MANCHESTER COLLEGE

LTE CITY CENTRE

PROPOSED SITE DRAINAGE
GENERAL ARRANGEMENT
SHEET NUMBER

CC-ACM-PH1-XX-DR-D-9000

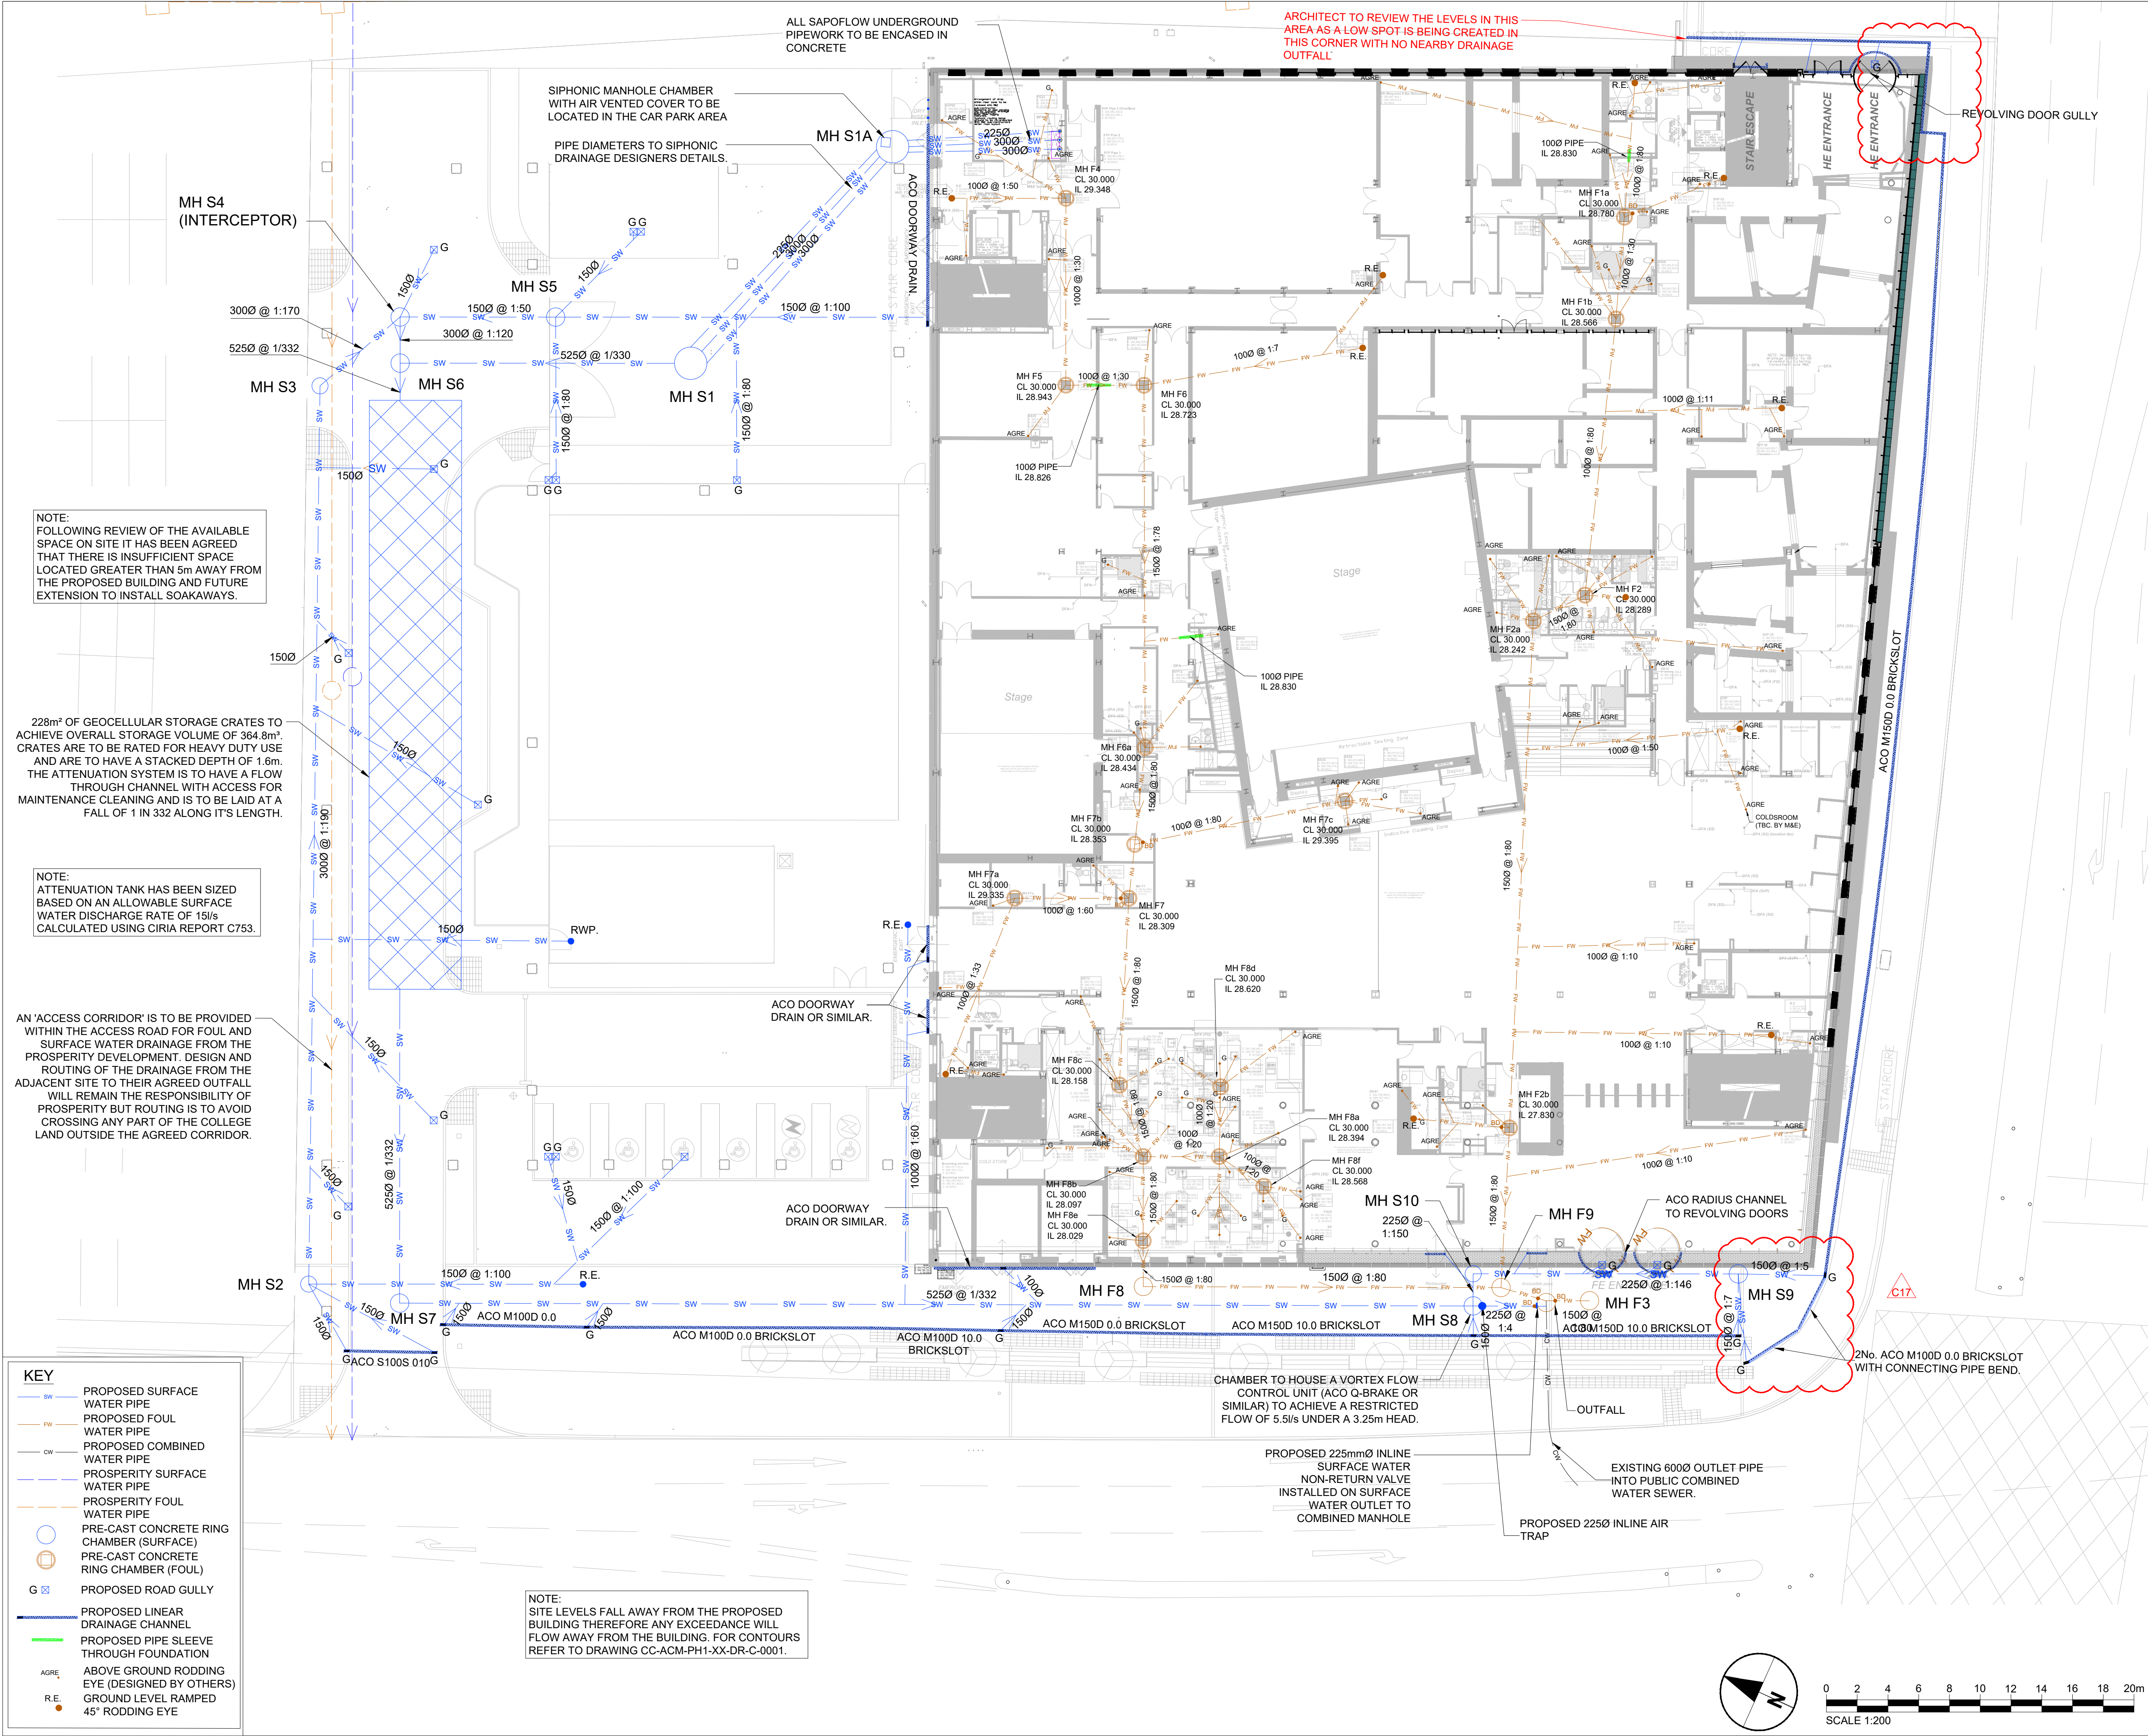
ARCHITECT TO REVIEW THE LEVELS IN THIS AREA AS A LOW SPOT IS BEING CREATED IN THIS CORNER WITH NO NEARBY DRAINAGE OUTFALL
